Quantum CoPro Firmware Release Notes

Models 140CPU65150, 140CPU65160, 140CPU65260, 140CPU65860*

Exec Revision History

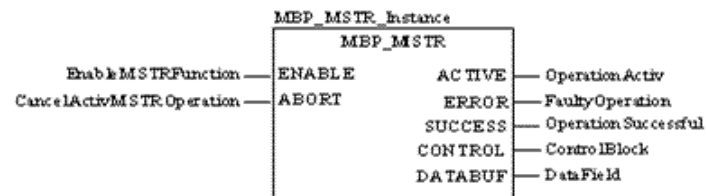
I/O Scanning to devices with varying response times may stop if it receives a reset (RST) from the device.

A fix was implemented so that when the Quantum CoPro receives a RST from the server on an established connection, it closes the existing connection and tries to establish a new connection on a different port.
